**ADDENDUM NUMBER 3
BID NUMBER IFB 20-023**

Summer Roofing Projects 2021

ISSUED: January 14, 2021

**PURCHASING DEPARTMENT
UNIFIED SCHOOL DISTRICT 500
2010 N. 59th STREET, ROOM 370
KANSAS CITY, KANSAS 66104
913-551-3200**

Morse Early Childhood Center
912 S. Baltimore, Kansas City, KS 66105

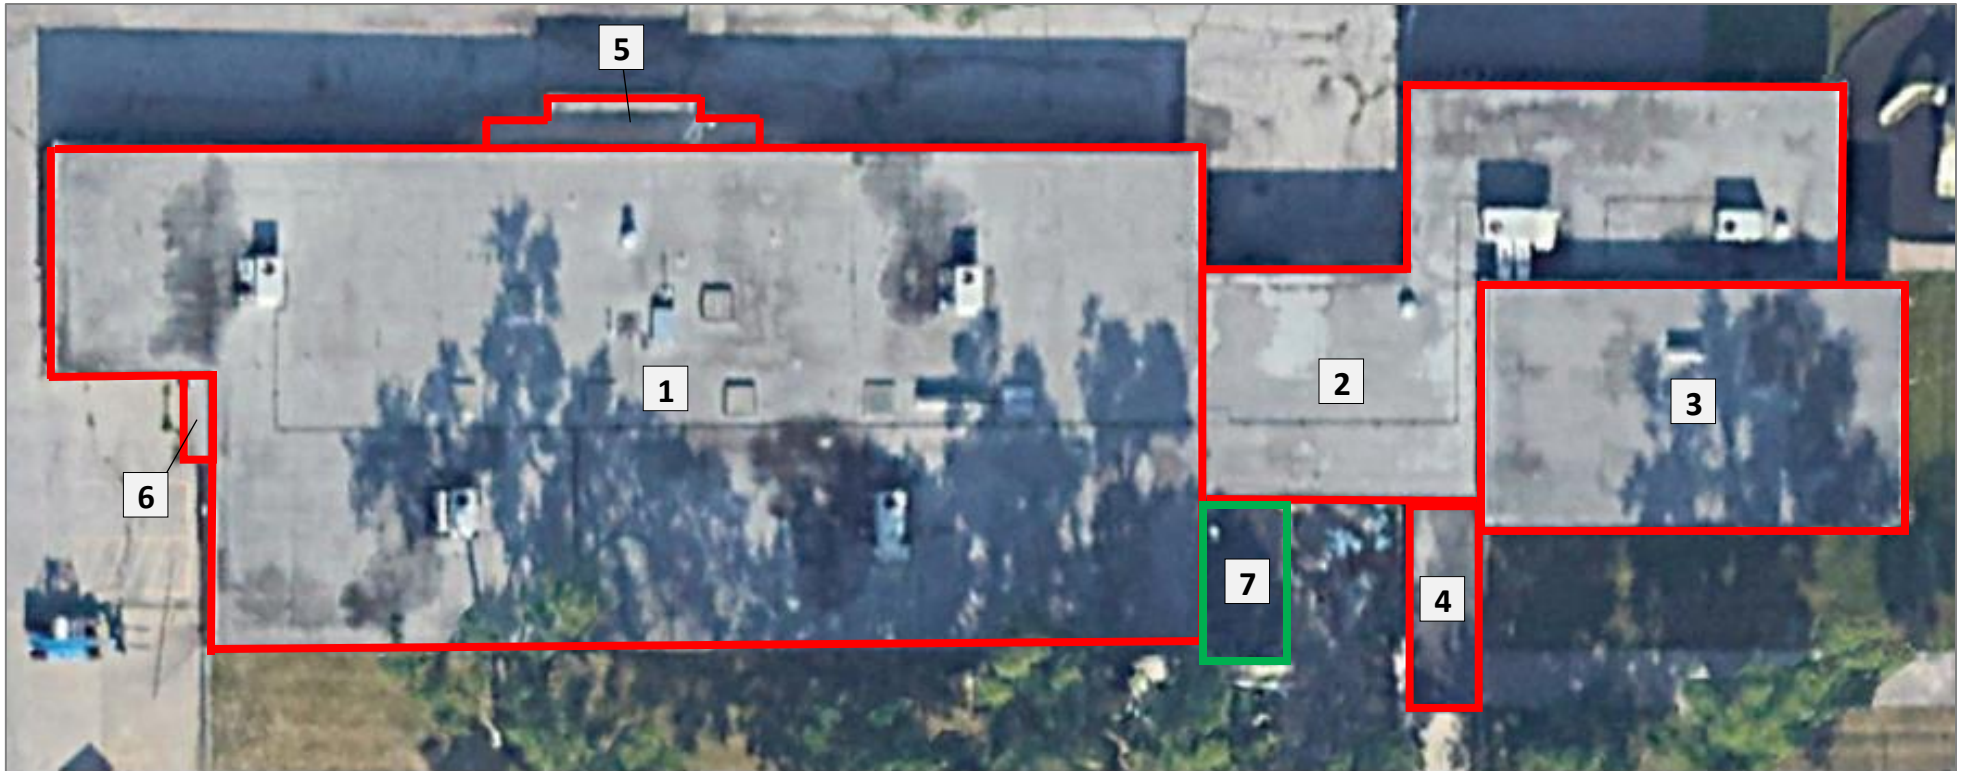
1. Remove Roof 4 from the Base Bid. Provide an Alternate Bid for replacing Roof 4.
 2. Add Roof 7 on attached roof plan to scope of work.
 - a. Clean all gutters.

- b. Coat bare areas with cold asphalt adhesive and embed gravel.
 3. Install seven (7) new skylight lenses over existing skylight curbs.
 - a. Color shall be “Clear over White”

4. Include in your bid the replacement of the south Trane RTU on Roof 2 by Stanger Industries.
 - a. Stanger contact: Matt Stone – 816-288-8710
 - b. Include the installation of new duct curbs and flashing on Roof 3 as specified by Stanger.
